Nomad

ALERT SERVICE BULLETIN

FLIGHT CONTROLS — AILERONS — INSPECTION AND INCORPORATION OF MOD N634

ANMD-57-9
Page 9

Figure 1 Aileron Support Board

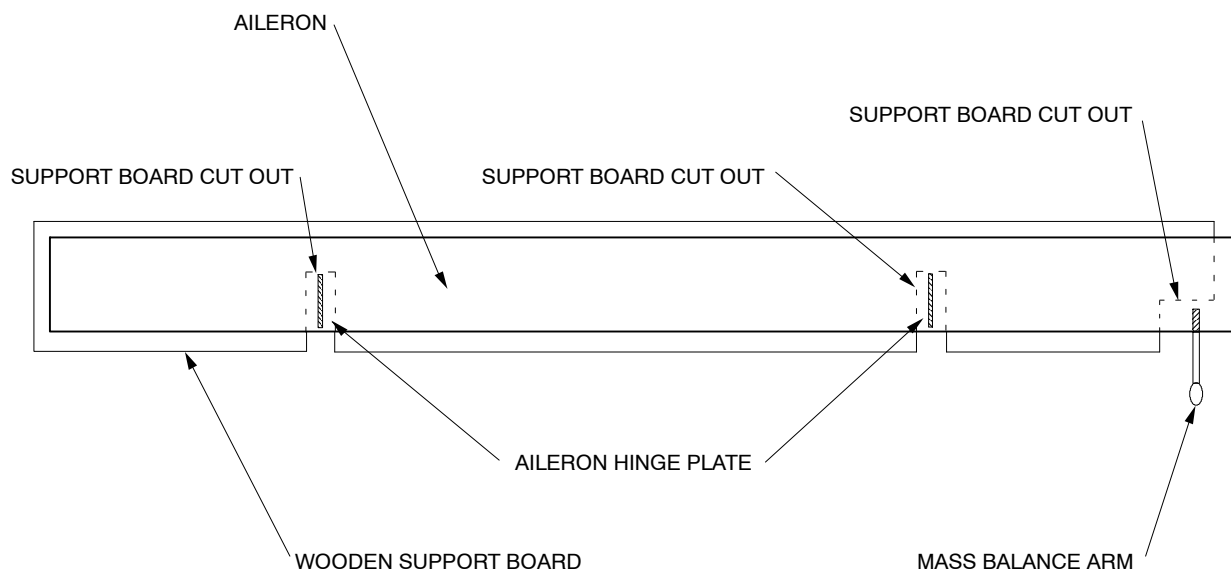
- (4) Prior to starting the repair, the aileron should be supported on the lower skins for the complete length of the aileron by laying it on a solid flat surface having suitable cutouts for the hinge plates and mass balance arm (Ref Figure 1).
- (5) Remove all mass balance weights, bolts, nuts and washers and retain for later reassembly.

Figure 2 Extent of Aileron De-riveting

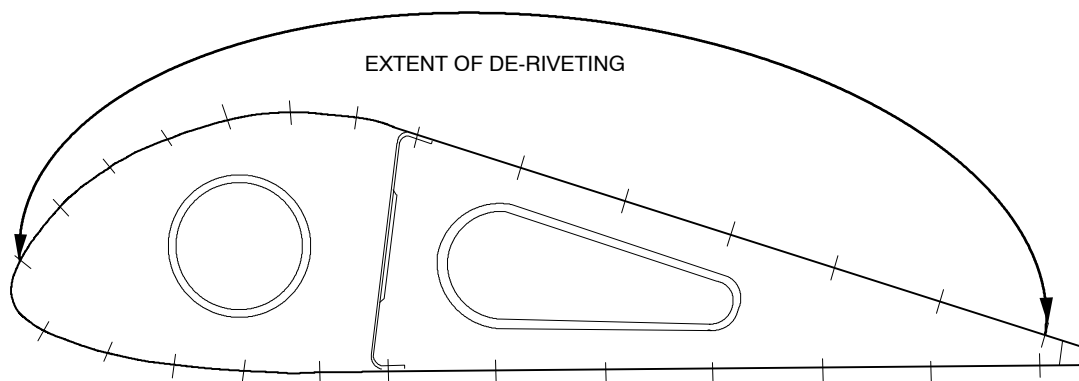
- (6) De-rivet and partially remove the upper leading edge skin and trailing edge skin to allow access to both sides of the aileron spar (Ref Figure 2).

Figure 3 Aileron Leading Edge Rib Rework

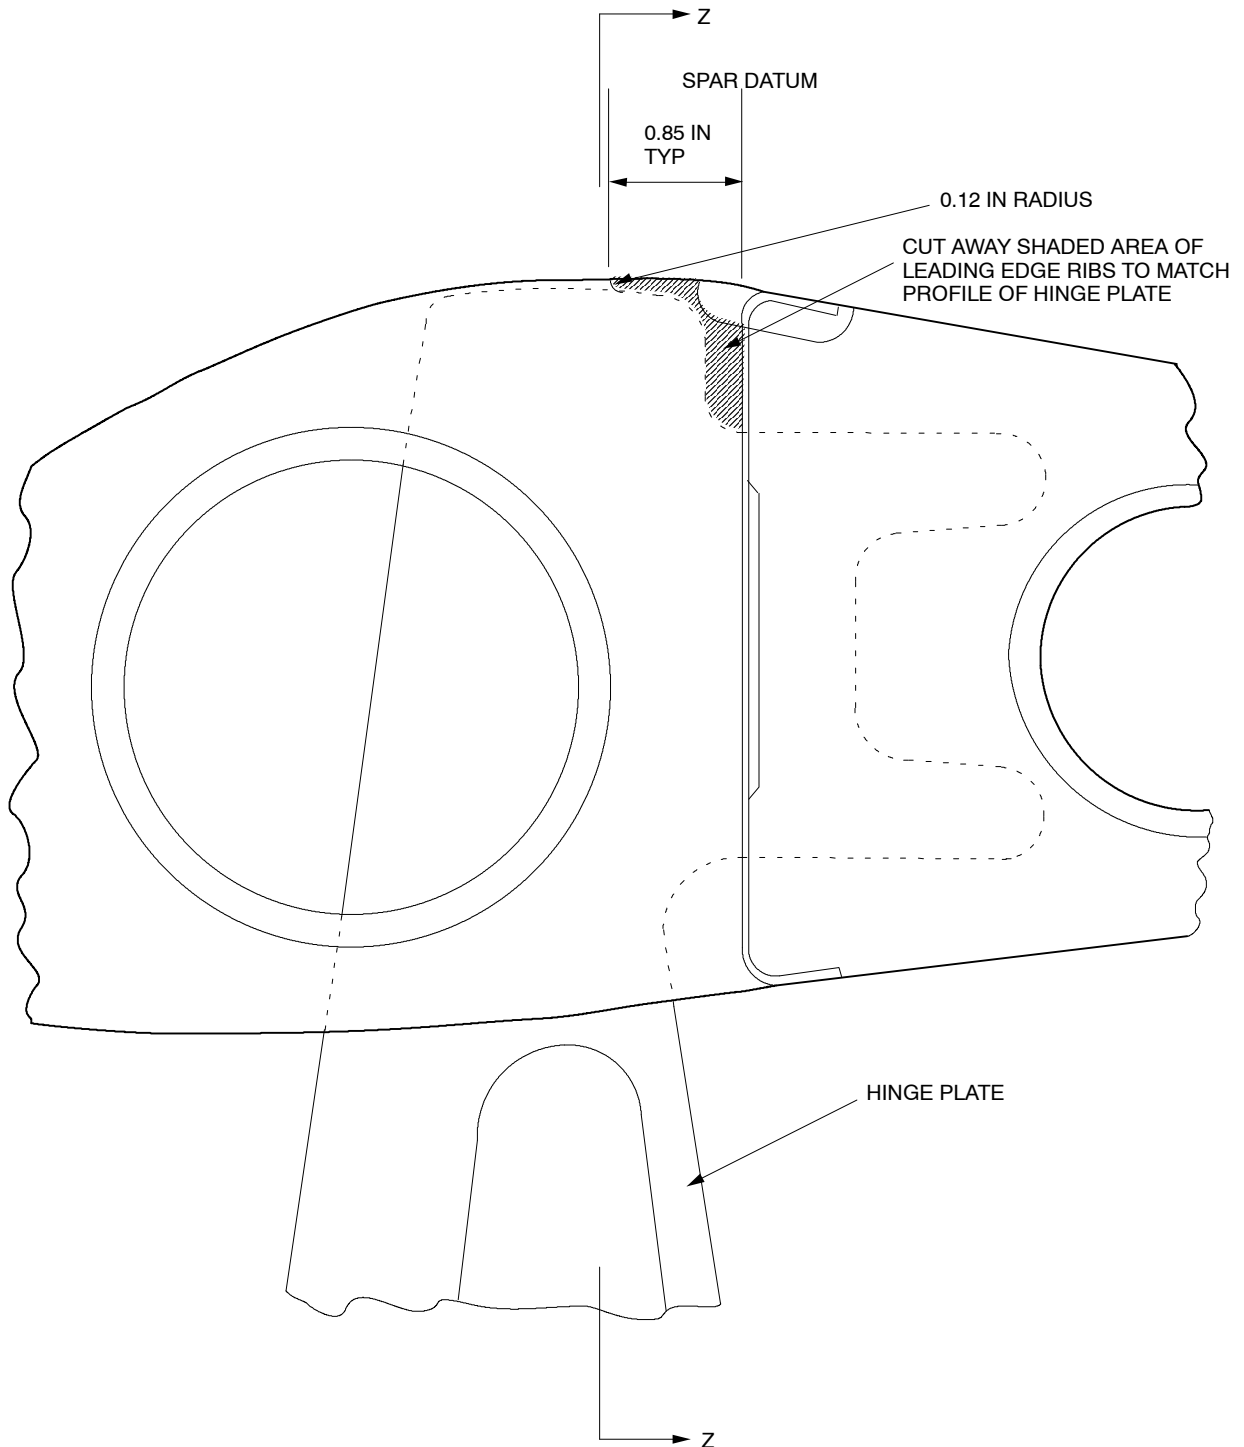
- (7) Cut away shaded area of leading edge ribs PN 1A/N-24-107 and 1B/N-24-107 to match profile of hinge plate PN 1/N-24-108 (Ref Figures 3, 4,5and 6).

Figure 4 Reinforcing Angle — Installation LH Aileron

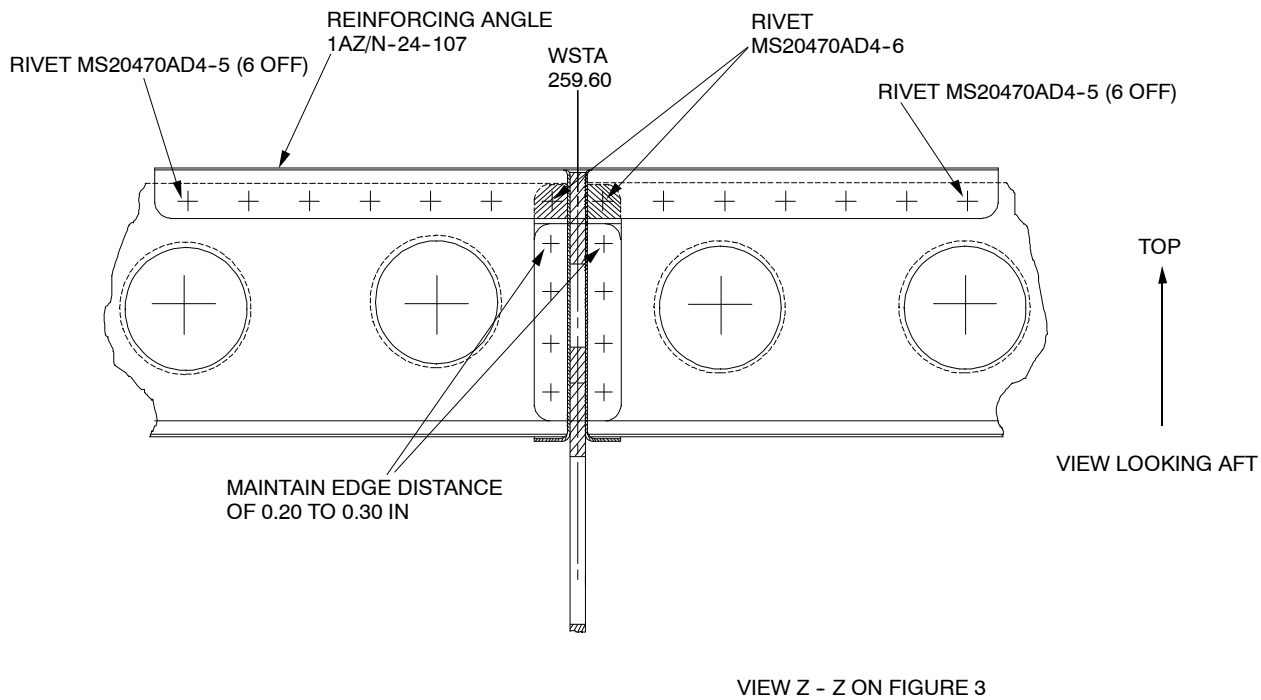
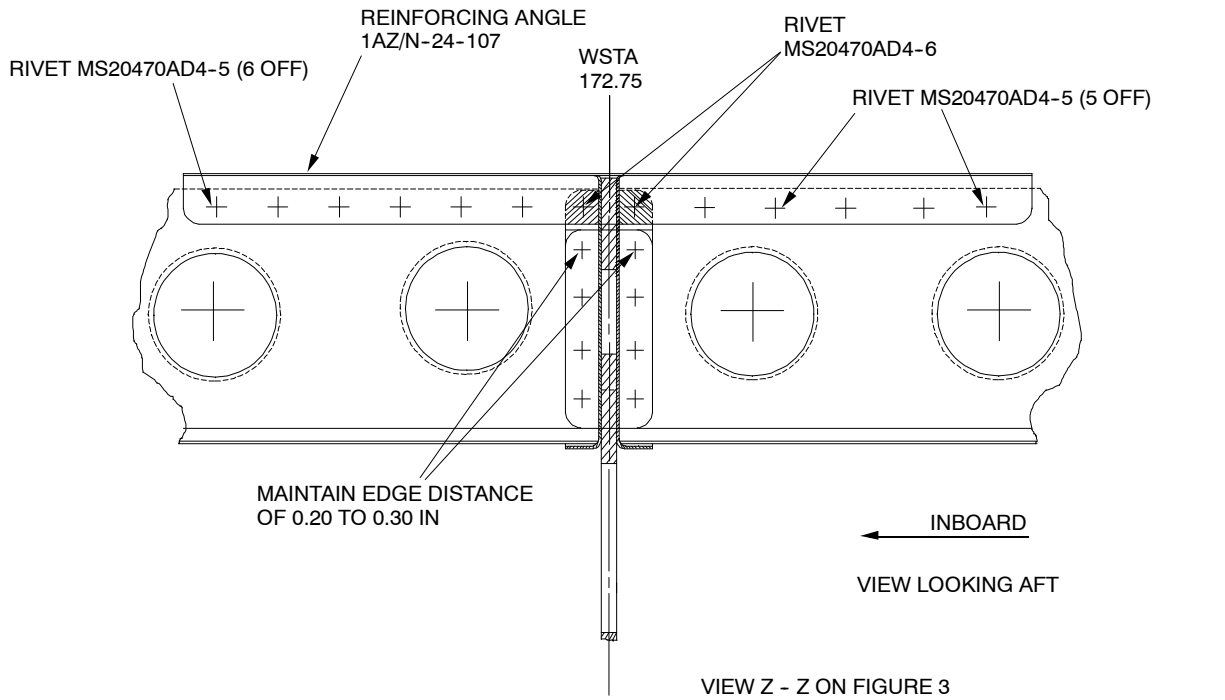
- (8) Touch up bare metal surfaces using Alodine 1200 and then zinc chromate primer.
- (9) Position reinforcing angle PN 1A/N-03-793 symmetrically about hinge plate to match the aileron contour at WSTA 172.75 and WSTA 259.60 and existing rivet holes in spar.

- (10) Maintaining edge distance of 0.20 to 0.30 in, backdrill the reinforcing angle. Remove the angle and deburr all newly drilled holes. Vacuum all metal particles from inside the aileron.

- (11) Wet assemble reinforcing angle PN 1A/N-03-793 using pigmented jointing compound (Ref MM Chap 20-30-00) and rivet to spar (Ref Figures 4, 5 and 6).

Figure 7 Aileron Rivet Scheme — Plan View

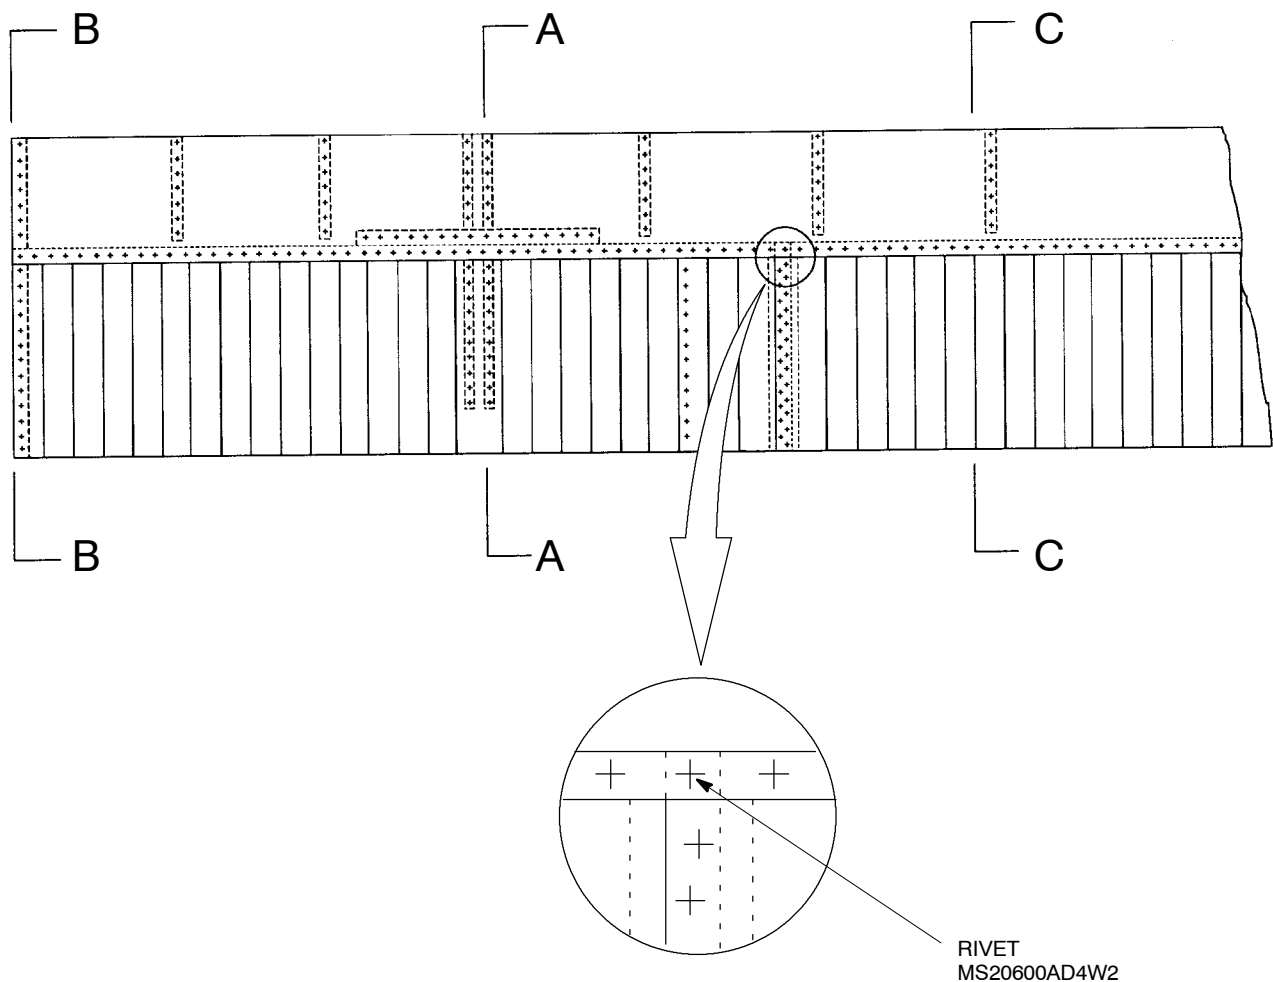
- (14) Using a Barium Chromate jointing compound, wet assemble and rivet the leading edge and trailing edge to restore the aileron to its original condition (Ref Figures 7 and 8).

Figure 10 Aileron Static Balancing Tool — Local Manufacture

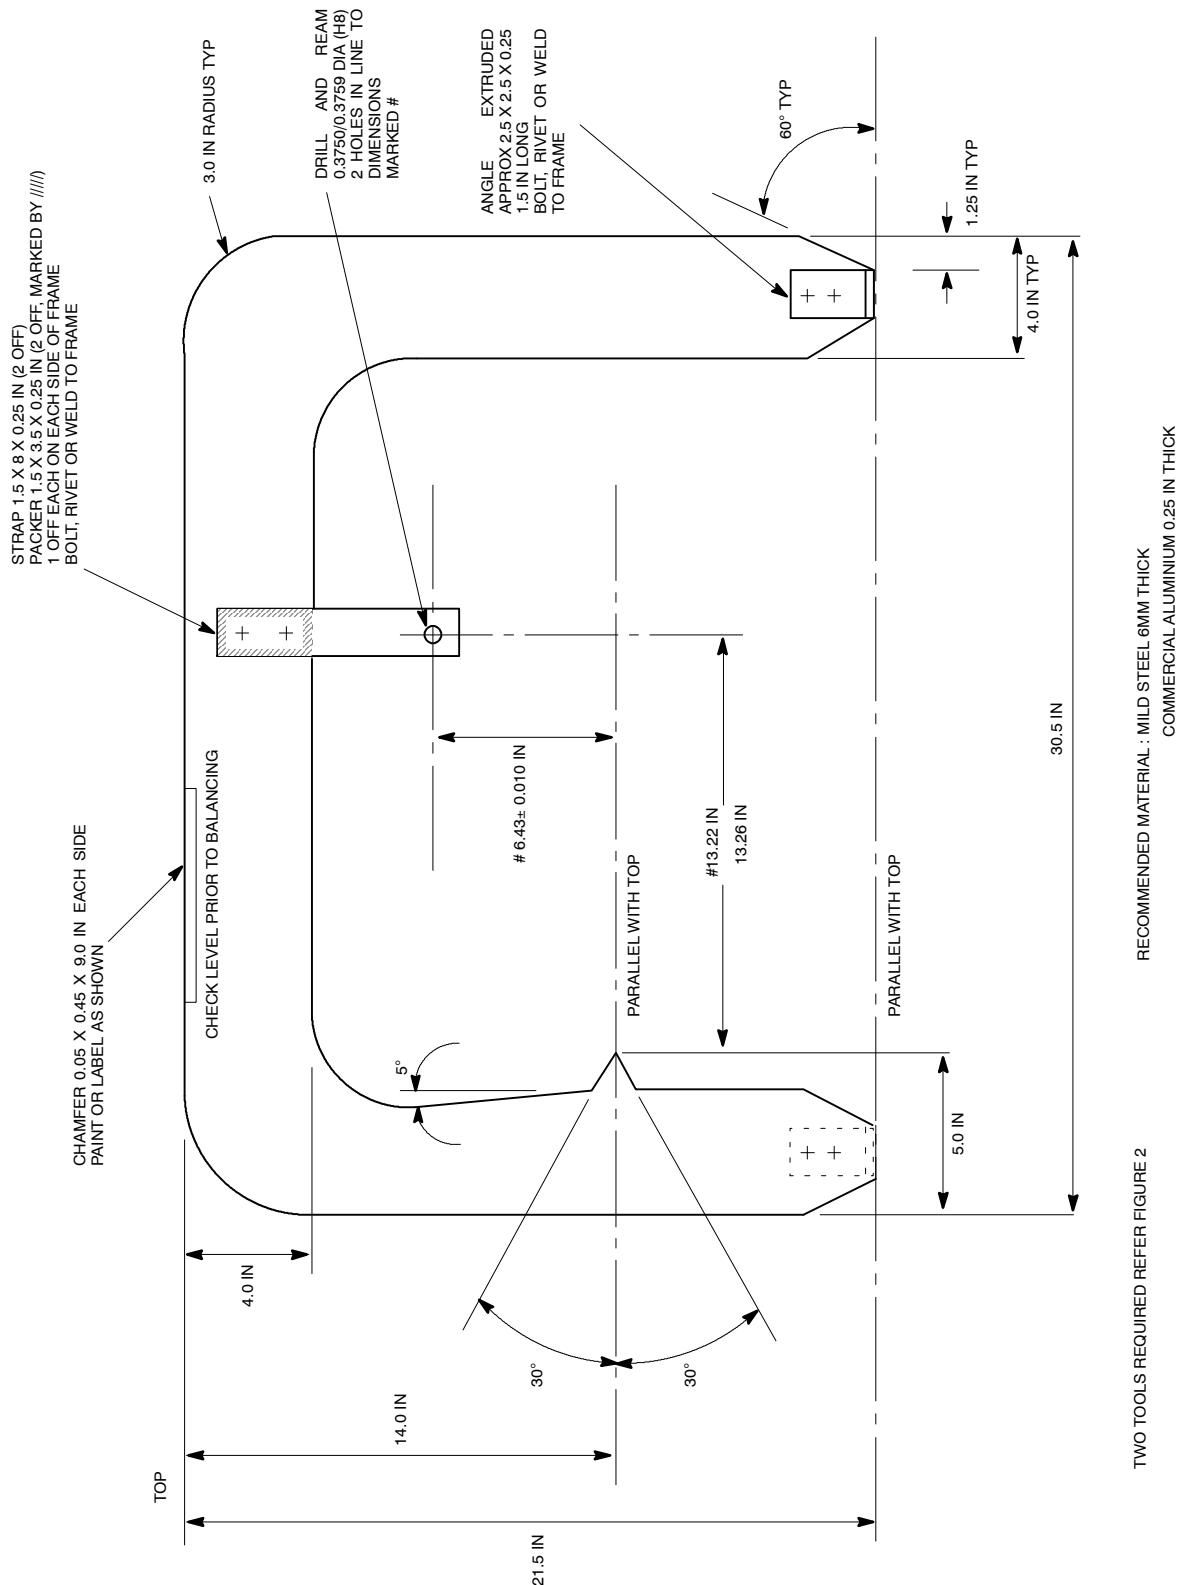
- (1) Manufacture two balance tools as described in Figure 10.
- (2) Stand both tools upright on a flat surface and suspend the aileron in an inverted position from the single strap fixed to each of the tools.

- (3) Ensure the horizontal level of the tools at the position indicated (Ref Figure 10) prior to beginning the balance procedure by packing under either leg.
- (4) Carry out a balance check in accordance with Part 3 step (3) to (10).
